## PCI-SIG ENGINEERING CHANGE NOTICE

<b>TITLE:</b>	Surprise Down Error & Link Up Additions
<b>DATE:</b>	4 Feb 2004 (updated 10 June 2004)
<b>AFFECTED DOCUMENT:</b>	PCI Express Base Specification Revision 1.0a
<b>SPONSOR:</b>	David Harriman, Intel Corporation

Figure 7-16: Link Capabilities Register

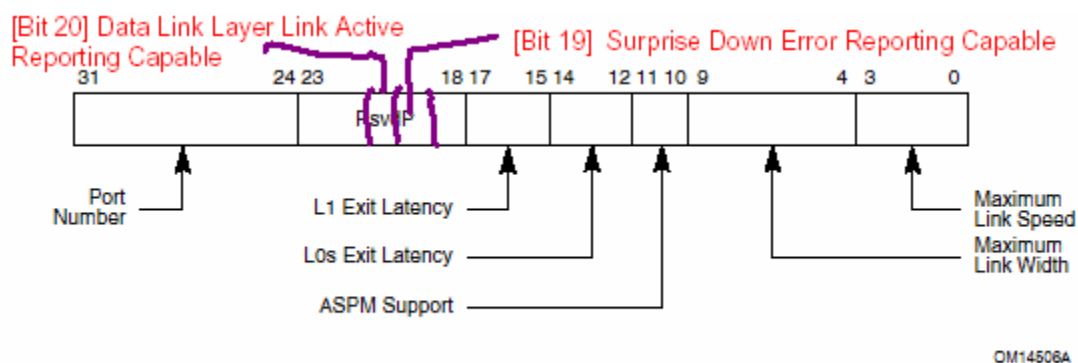
In 7.8.6, Link Capabilities Register:

Bit Location	Register Description	Attributes
...		
17:15	...	
<u>19</u>	<p><u>Surprise Down Error Reporting Capable – For a Downstream Port, this bit must be set to 1b if the component supports the optional capability of detecting and reporting a Surprise Down error condition.</u></p> <p><u>For Upstream Ports and components that do not support this optional capability, this bit must be hardwired to 0b.</u></p>	<u>RO</u>

Bit Location	Register Description	Attributes
<u>20</u>	<p><b><u>Data Link Layer Link Active Reporting Capable</u></b> – For a Downstream Port, this bit must be set to 1b if the component supports the optional capability of reporting the DL_Active state of the Data Link Control and Management State Machine.</p> <p><u>For Upstream Ports and components that do not support this optional capability, this bit must be hardwired to 0b.</u></p>	<u>RO</u>
31:24	...

Figure 7-18: Link Status Register

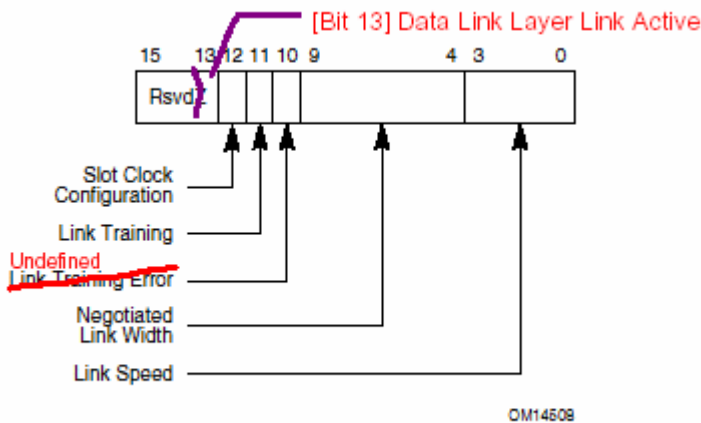
*In 7.8.8, Link Status Register (note: preceding ECN removing Training Error reflected in the markups below):*

Bit Location	Register Description	Attributes
...		
<u>13</u>	<p><b><u>Data Link Layer Link Active (Optional)</u></b> – Set to 1b when the Data Link Control and Management State Machine is in the DL_Active state, 0b otherwise.</p> <p><u>If this optional status reporting capability is not implemented, this bit must be hardwired to 0b.</u></p>	<u>RO</u>

Table 7-24: Uncorrectable Error Status Register

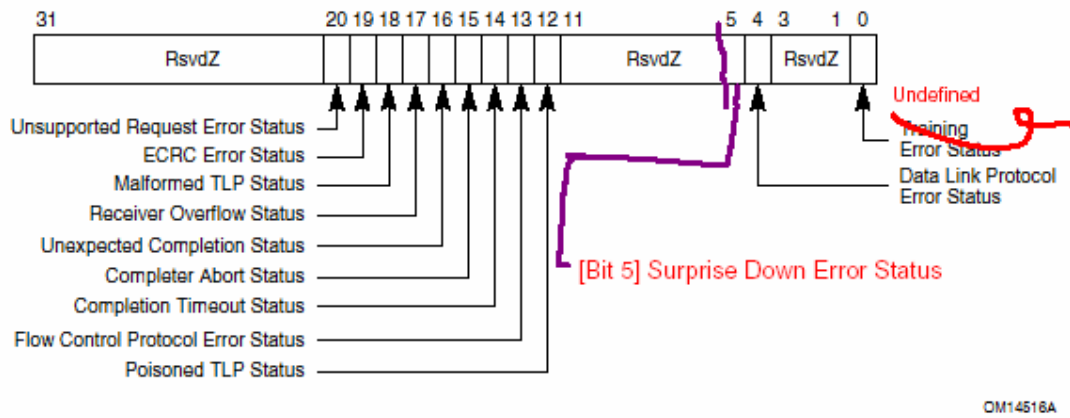
In 7.10.2, Uncorrectable Error Status Register (note: preceding ECN removing Training Error reflected in the markups below):

Bit Location	Register Description	Attributes	Default Value
...			
<u>5</u>	<u>Surprise Down Error Status (Optional)</u>	<u>RW1CS</u>	<u>0</u>
...

Table 7-25: Uncorrectable Error Mask Register

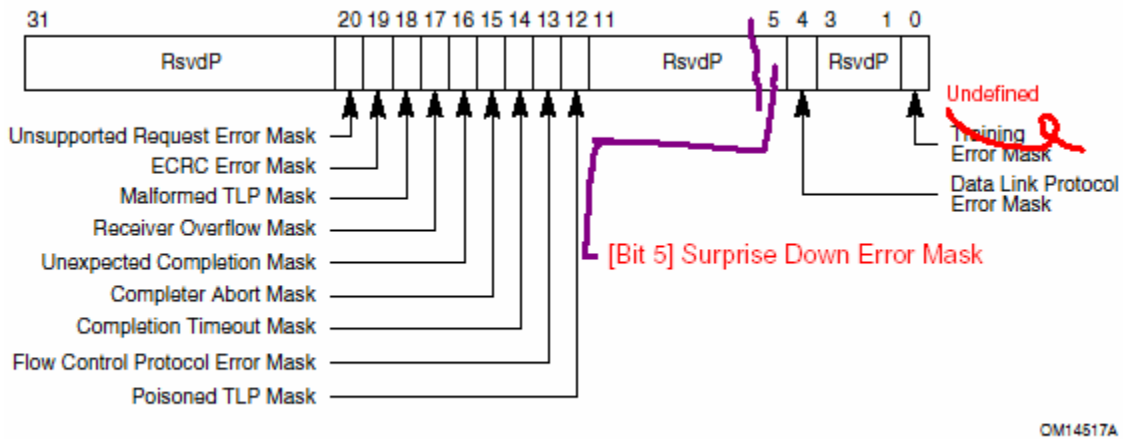
In 7.10.3, Uncorrectable Error Mask Register (note: preceding ECN removing Training Error reflected in the markups below):

Bit Location	Register Description	Attributes	Default Value
...			
<u>5</u>	<u>Surprise Down Error Mask (Optional)</u>	<u>RWS</u>	<u>0</u>
...

Figure 7-30: Uncorrectable Error Severity Register

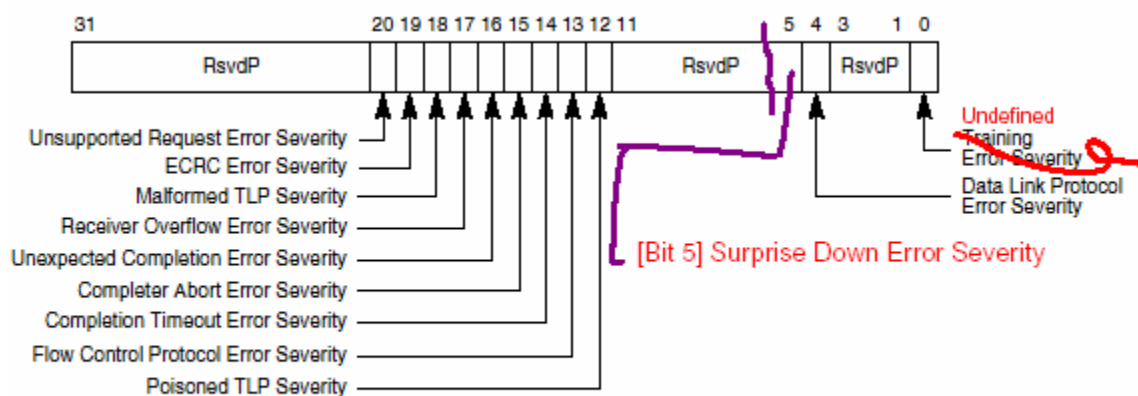
In 7.10.4, Uncorrectable Error Severity Register (note: preceding ECN removing Training Error reflected in the markups below):

Bit Location	Register Description	Attributes	Default Value
...			
<u>5</u>	<u>Surprise Down Error Severity (Optional)</u>	<u>RWS</u>	<u>1</u>
...
